## PRODUCT / PROCESS CHANGE NOTIFICATION

1.1 Company		STMicroelectronics International N.V
1.2 PCN No.		CRP/22/12692
1.3 Title of PCN		CHANGE OF SUPPLIER FOR 3CP40620 (CARRIER TAPE Wi 16mm QFN/LGA 8x8 dsp)
1.4 Product Category		Refer to impacted product list
1.5 Issue date		2022-02-18

### PCN - CHANGE OF SUPPLIER FOR 3CP40620 (CARRIER TAPE Wi 16mm QFN/LGA 8x8 dsp)

#### CURRENT: PEAK

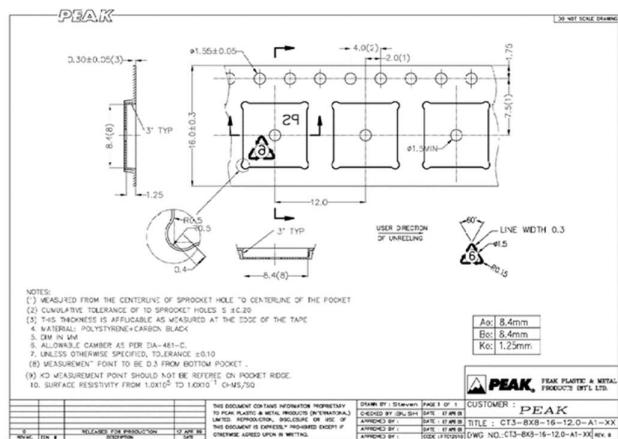
Change of supplier for ST material code reference: 3CP40620 (CARRIER TAPE Wi 16mm QFN/LGA 8x8 dsp) from PEAK to ADVANTEK which affected ST CALAMBA.

# Visual Inspection Report

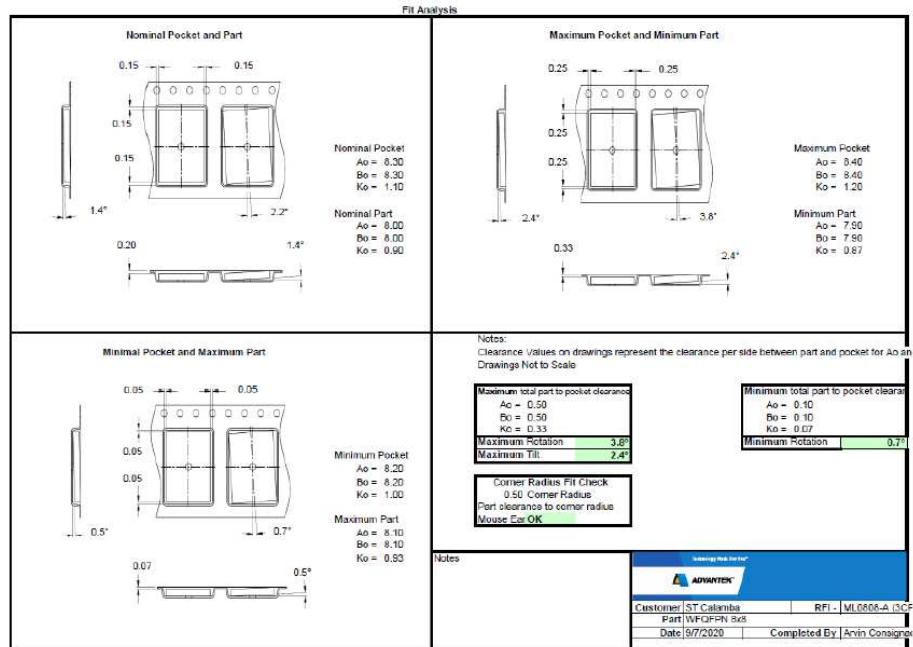
Visual inspection	Results
Does not contain stain or foreign material	Passed
No Damage	Passed
No Burr	Passed
Orientation	Passed
The component does not protrude above the top surface of the carrier tape	Passed
The component can be removed from the cavity in a vertical direction without mechanical restriction, after the top cover tape has been removed.	Passed
Lateral movement of the component is restricted to 1.0mm maximum	Passed
